From:	Maurice R Hogg
To:	Reis, Juliana
Cc:	Maria T Rodriguez; Lillian F Deprimo
Subject:	RE: CEMEX Miami Cement Plant & SCL Quarry (EPAID FLD981758485) - Exit Interview (Submittal 1 of 2)
Date:	Tuesday, January 5, 2021 4:37:41 PM
Attachments:	image004.png image005.png image006.png

This email serves as an exit interview for the Compliance Evaluation Inspection (CEI) conducted on Thursday, December 17, 2020, by the Florida Department of Environmental Protection (FDEP) to determine this facility compliance with the hazardous waste Federal and state regulations.

7. Universal Waste Lamps

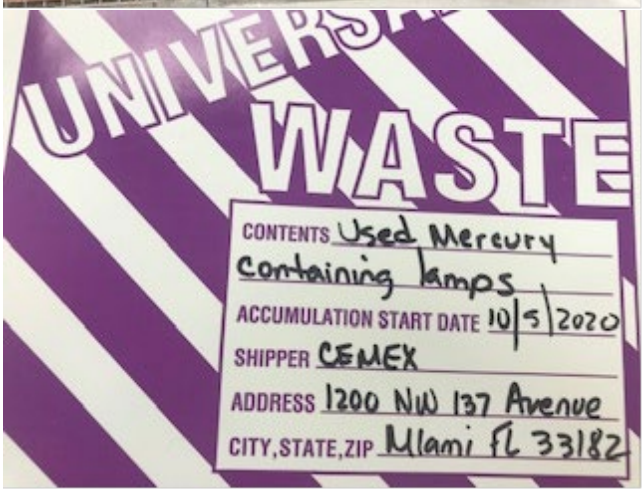
7. **Universal waste lamps – 40 CFR 273.13(d)**
    a. Provide pictures of the spent mercury lamps containers (attached picture) properly closed and sealed in order to prevent breakage. **Submitted on December 22, 2020**

Spent mercury lamps shall be specifically labeled as "universal waste-mercury-containing lamps", "waste mercury-containing lamps" or "used mercury-containing lamps".

b. Provide a corrective action picture of spent mercury lamp's containers properly labeled. **Submitted on December 22, 2020**

7. **Universal waste lamps – 40 CFR 273.13(d)**
    a. Provide pictures of the spent mercury lamps containers (attached picture) properly closed and sealed in order to prevent breakage.
        Spent mercury lamps shall be specifically labeled as "universal waste-mercury-containing lamps", "waste mercury-containing lamps" or "used mercury-containing lamps".
    b. Provide a corrective action picture of spent mercury lamp's containers properly labeled.

The photos below taken 12-22-20 , demonstrate that item **7 Universal waste lamps – 40 CFR 273.13(d)** of the CEI has been resolved. The spent mercury containers have been properly closed and sealed to prevent breakage, and labeled as specified.
